In the Matter of: Entergy Nuclear Operations, Inc. (Indian Point Nuclear Generating Units 2 and 3)	
	ASLBP #: 07-858-03-LR-BD01 Docket #: 05000247 05000286 Exhibit #: NYS000221-00-BD01 Admitted: 10/15/2012 Rejected: Other:	Identified: 10/15/2012 Withdrawn: Stricken:

From: Palla, Robert
Sent: Thursday, October 29, 2009 1:07 PM
To: Stuyvenberg, Andrew
Cc: iPRenewal NPEmails
Subject: Weather Runs 10 29 09.doc
Attachments: Weather Runs 10 29 09.doc

Indian Point Weather

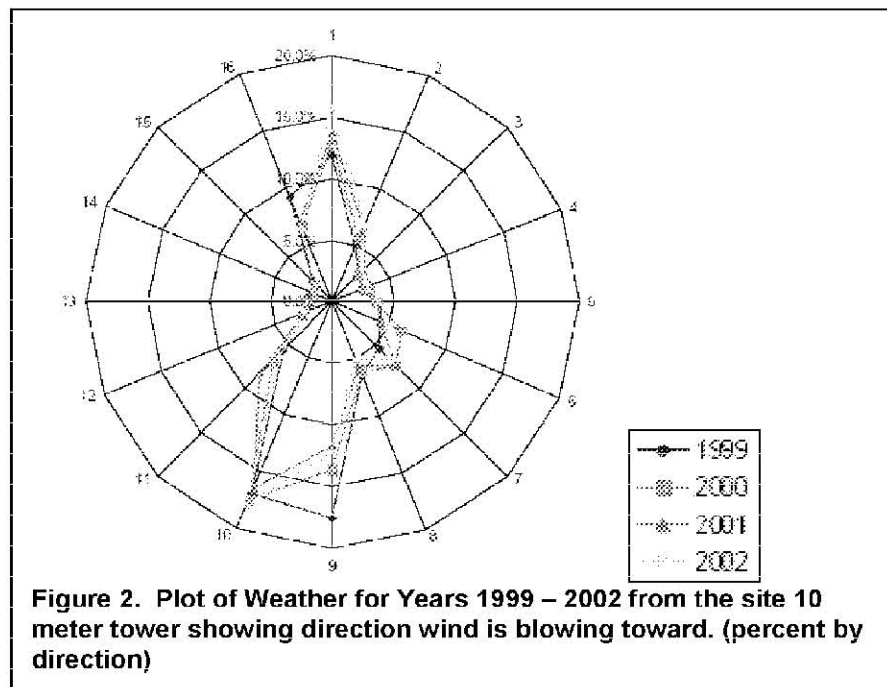
hourly weather samples (365 days x 24 hours/day) from the January 2000 to December 2004 IPEC 10 meter met tower data. The results of the averaged weather generate a wind rose

predominantly in the northerly direction as shown in Figure 1. Review of the process describing how the weather was averaged did not provide insights into why the wind rose is predominantly northerly.

dominant. Thus, the MACCS2 input of averaged weather used in the analysis does not appear to reflect the annual weather conditions. An analysis is needed using discrete years of weather data for each or at least some of the 5 years, without averaging weather, to understand the effects of weather on the SAMA conclusions.

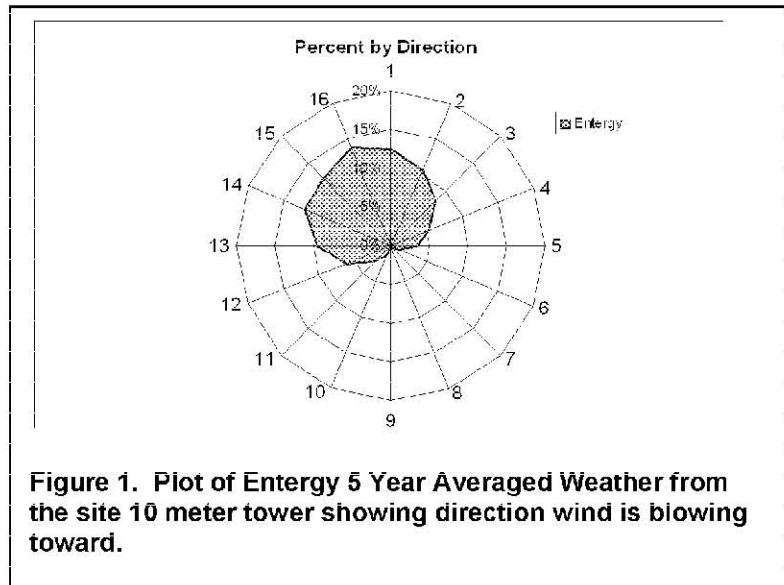
information provided in the Indian Point annual effluent reports for 1999 through 2002 (ML031220099, ML021260723, ML011240172, ML003714664), also for the 10 meter met tower. A wind rose was developed for each year from 1999 through 2002. Each of the weather files for the years 1999 thru 2002 are relatively similar, and the wind rose for each year of weather shows in Figure 2 that the northern and southern directions are

1. Additional information is needed in the form of consequence analyses using annual, rather than averaged, weather data. An analysis of at least one specific weather year should be conducted using the 10 meter weather information available from the site. Use of the 10 meter station may be expected to show a greater likelihood of wind in the northerly and southerly directions following the river. It may be beneficial to also perform an analysis using the weather data from the 120 meter station available from the site.
